## DEPARTMENT OF PLANNING AND ZONING PLANNER'S REPORT

RE: Design Review – 3365 Northside Drive, Revised

11. Front porch widths must be between 80% and 100% of the adjacent façade. The porch is 70% of the façade, which is not compliant.

#### **Response to Design Review Recommendations:**

SITE PLAN

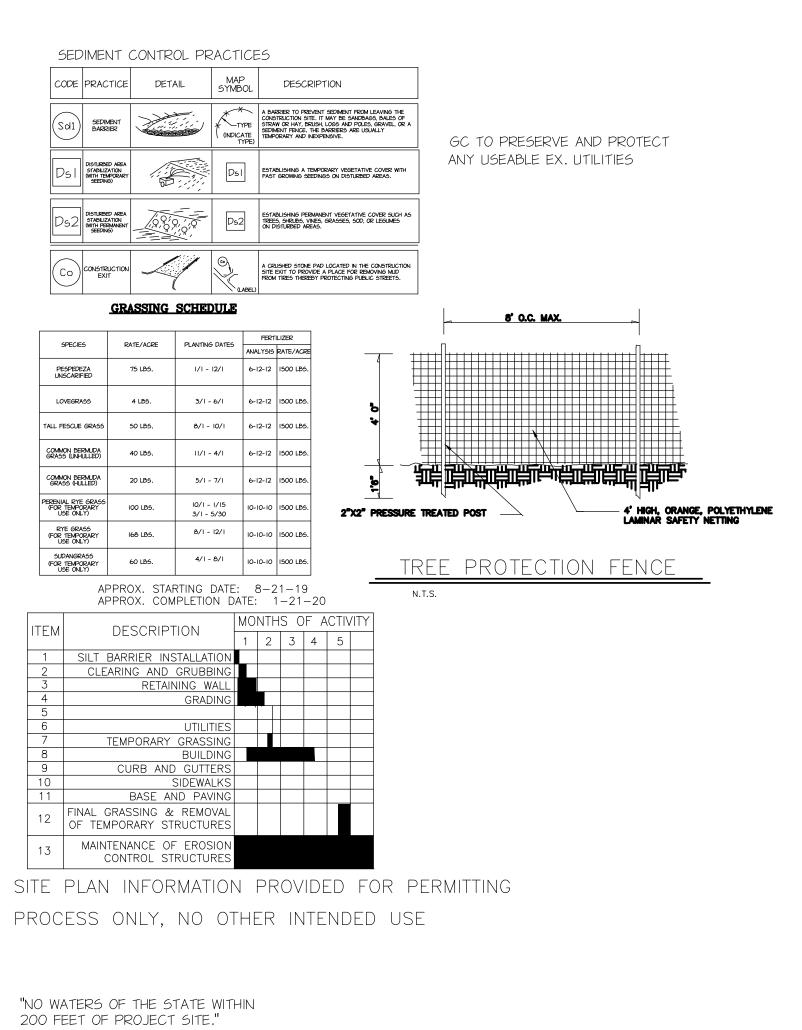
The plans should include a new sidewalk on each enfronting street, with a minimum 1' landscape zone and 4' clear zone.

The revised site plan shows a sidewalk along Northside Drive, with no sidewalk shown along Old Jonesboro Road. The applicant states she wishes to build a partial sidewalk along Old Jonesboro Road. A partial sidewalk is not compliant.

A minimum of one tree is required every 50' in the supplemental area. The application should be revised to ensure at least one tree is located every 50' along both Northside Drive and Old Jonesboro Road frontages. **A-7.0**

The driveway is 15' wide at the curb but expands towards the garage, which is not compliant. A-7.0 Design Exception Requested (Driveway width increased to 18' to allow some off-street parking)

Install a full sidewalk on Northside Dr with a partial sidewalk on the right side of the driveway of Old Jonesboro Rd - stopping on the left side of the driveway before the curvature.

A-3.0

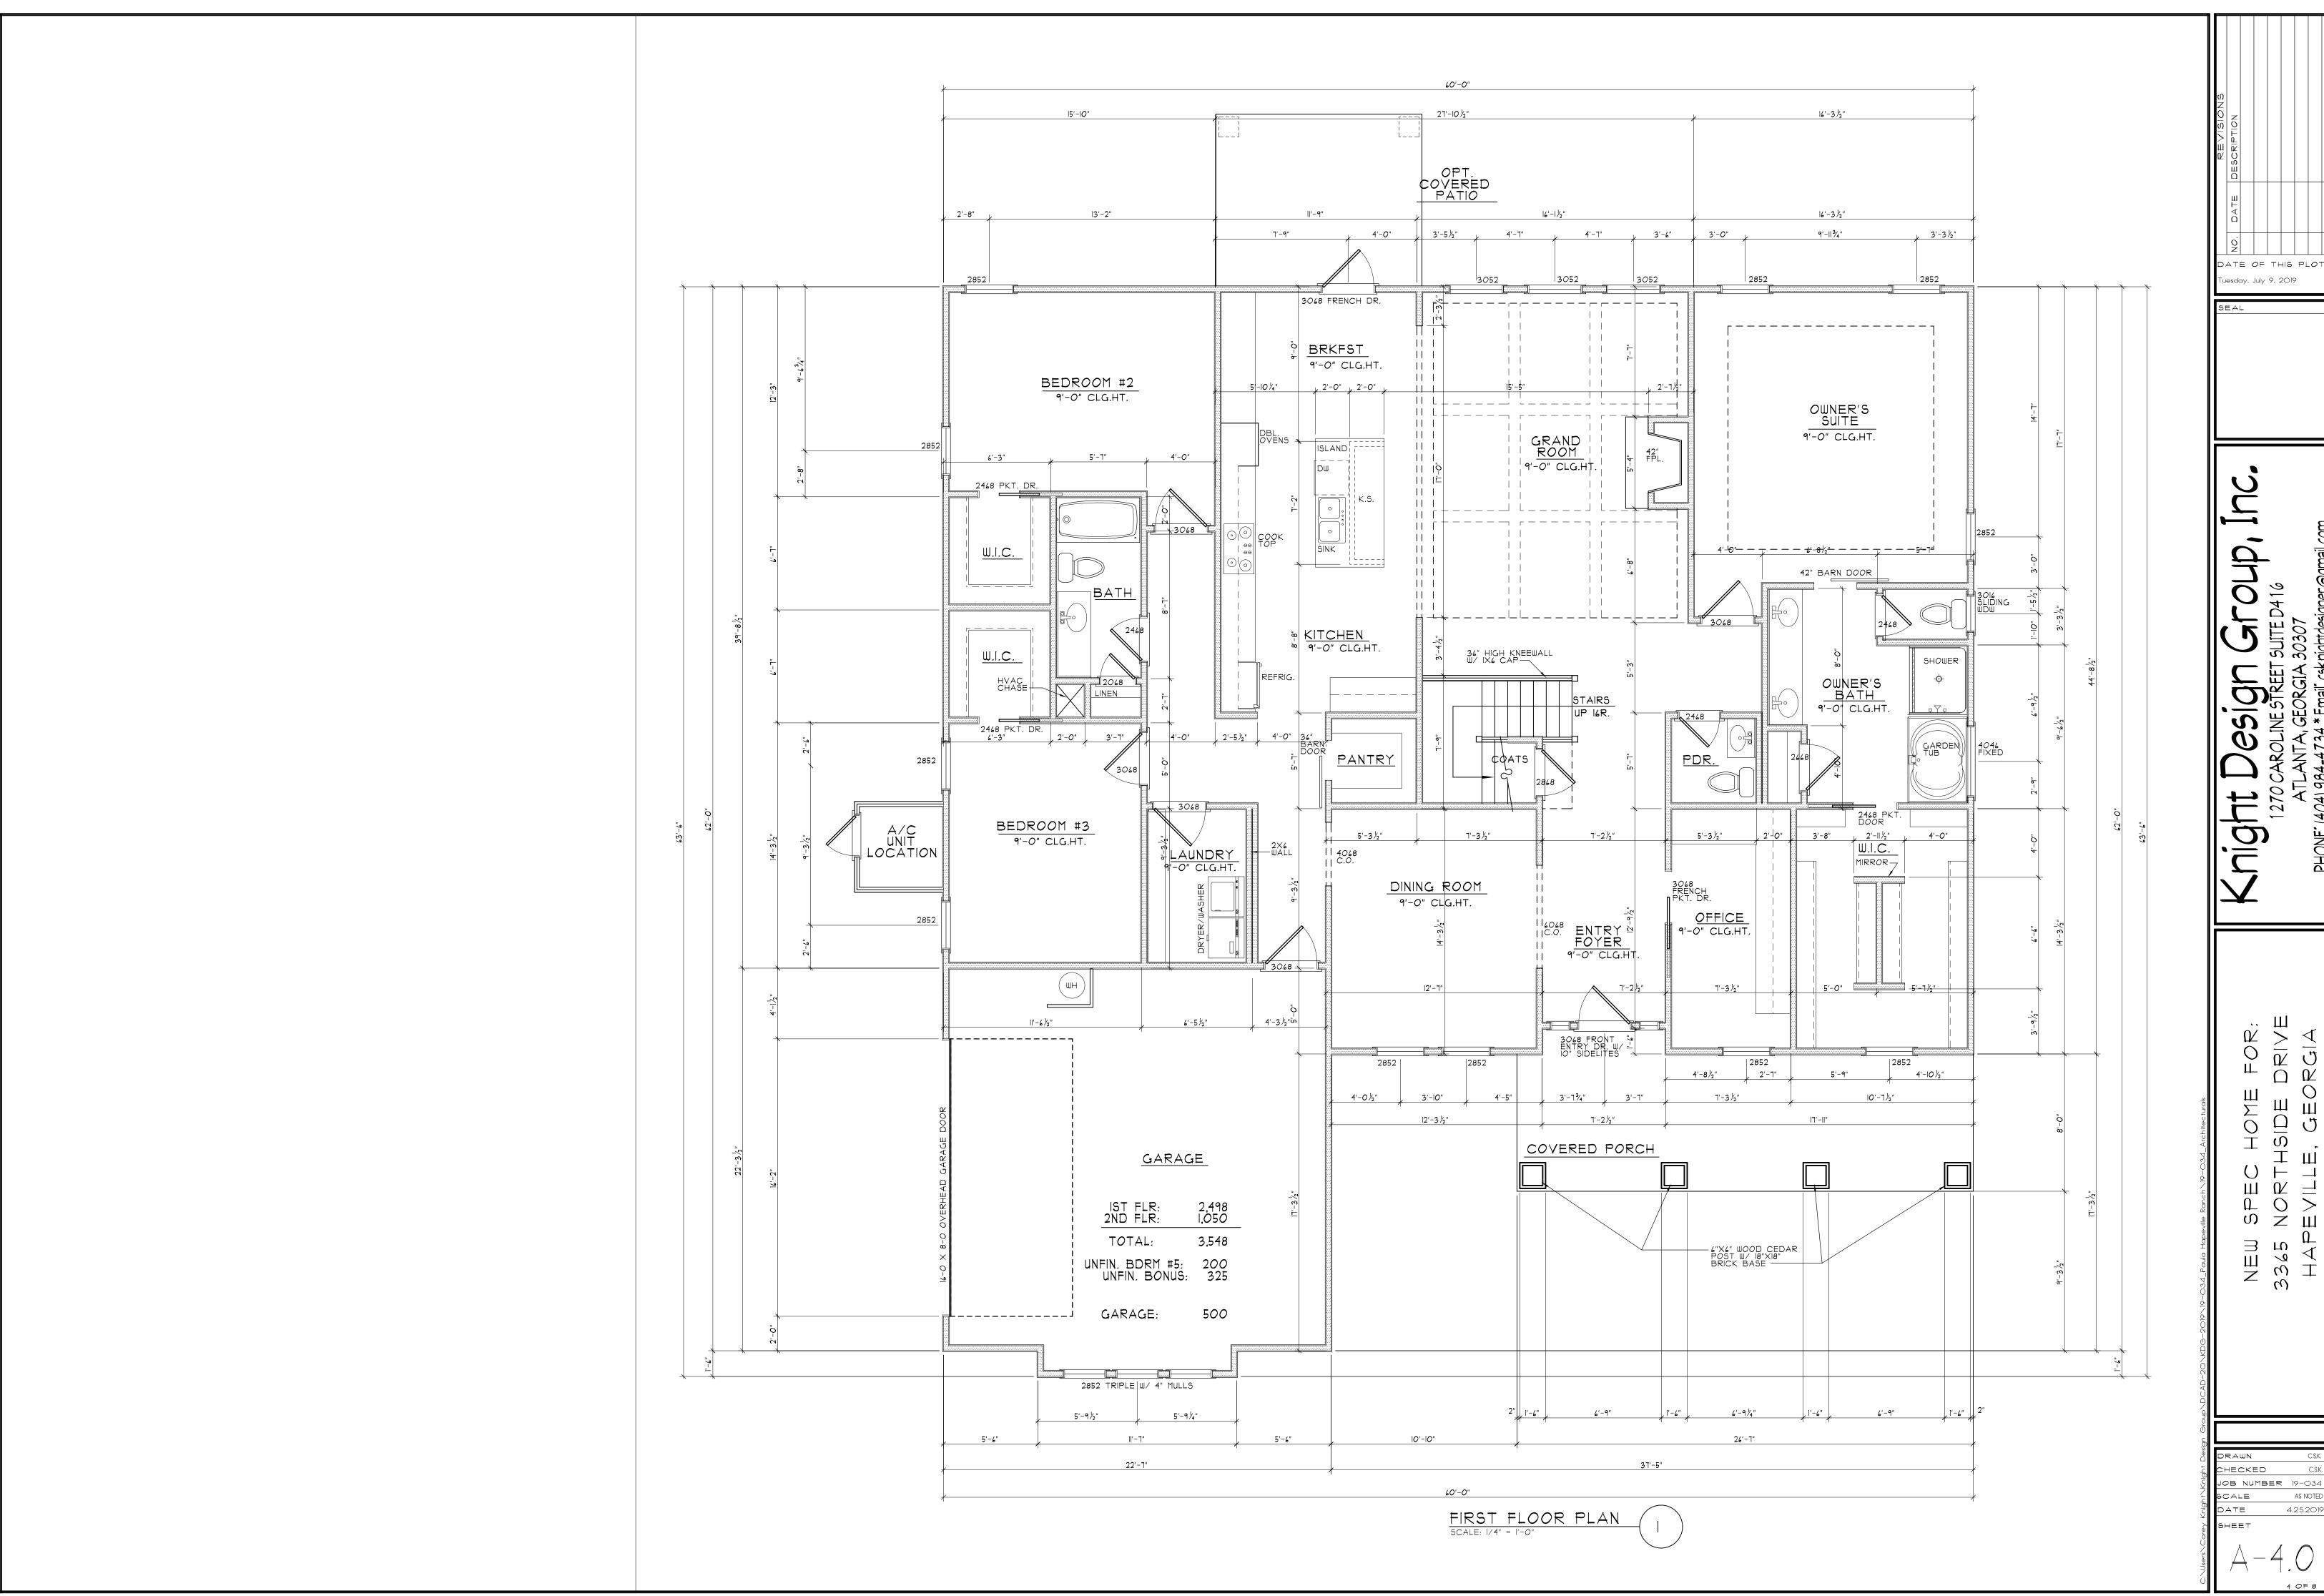
9. House is built on a slab foundation. A design exception is required for a porch built at grade.

10. The minimum clear depth between the front façade and the outside of the porch columns is 8'. The clear depth is 6' at its narrowest, which is not compliant.

#### The porch is 71% of the adjacent façade, which is not compliant.

House is built on a slab foundation. A design exception is required for a porch built at grade. A-3.0 & A-4.0 Design Exception Requested (Per our discussion at the initial design meeting

The minimum clear depth between the front façade and the outside of the porch columns is 8'.

The clear depth is 6' at its narrowest, which is not compliant. A-3.0 & A-4.0

Front porch widths must be between 80% and 100% of the adjacent façade. The porch is 70% of the façade, which is not compliant. **A-3.0 & A-4.0** (Changes made as discussed & agreed at the initial design meeting)
